UNITED STATES PATENT AND TRADEMARK OFFICE

APPLICATION NO.	FILING DATE	FIRST NAMED INVENTOR	ATTORNEY DOCKET NO.	CONFIRMATION NO.
10/587,091	07/20/2006	Salvatore Carbone	RUBNP01	8907
49691	7590	04/14/2010	EXAMINER	
IP STRATEGIES			LONG, ROBERT FRANKLIN	
12 1/2 WALL STREET				
SUITE E			ART UNIT	PAPER NUMBER
ASHEVILLE, NC 28801			3764	
			MAIL DATE	DELIVERY MODE
			04/14/2010	PAPER

Office Action Summary	Application No.	Applicant(s)
	10/587,091	CARBONE, SALVATORE
	Examiner	Art Unit
	Robert F. Long	3764

DETAILED ACTION

FIG. 6

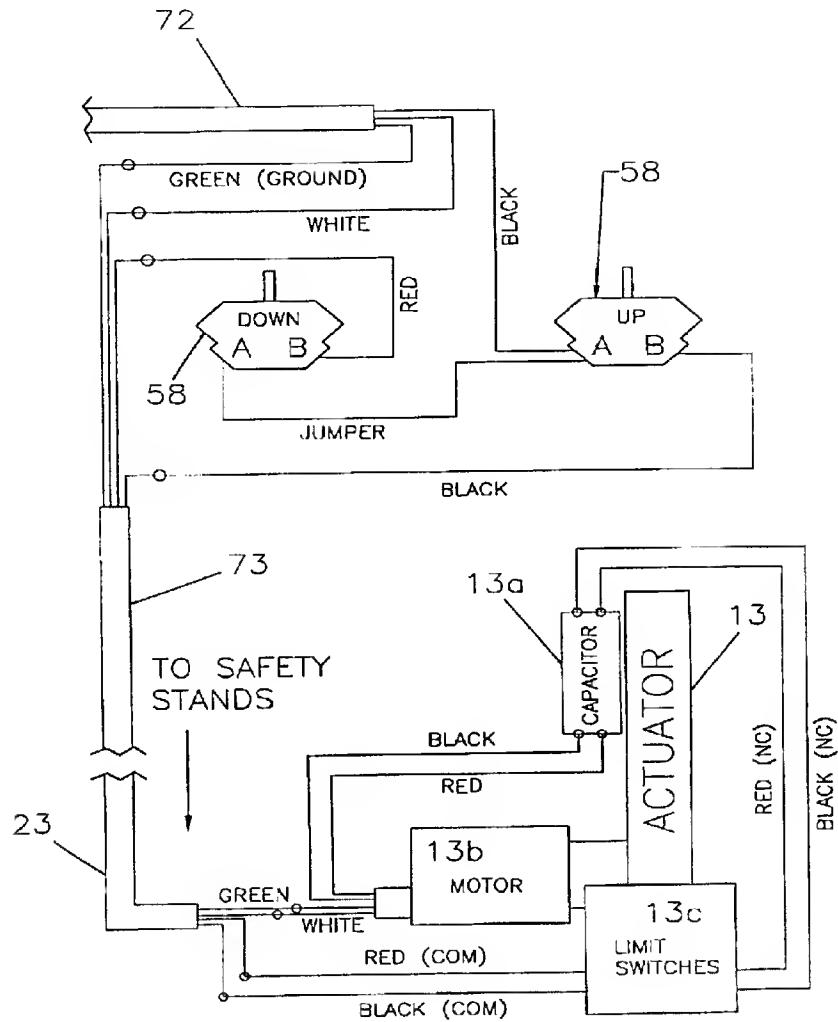
Regarding claims 22-23, and 29, Capizzo discloses an electronic switchboard (control circuit figure 6) that is adapted to position the support members 6/6a (selectable raising and lowering by user input, column 4, lines 50-67), representing arm positions chosen by the user according to exercises done and a foot support/rest having the command device disposed on the foot support/rest (foot pedal controller assembly 3, column 6, lines 65-67, column 7, lines 1-49, figures 4-6). See figure 6 below for control circuit and foot pedals (#58) command device schematic –
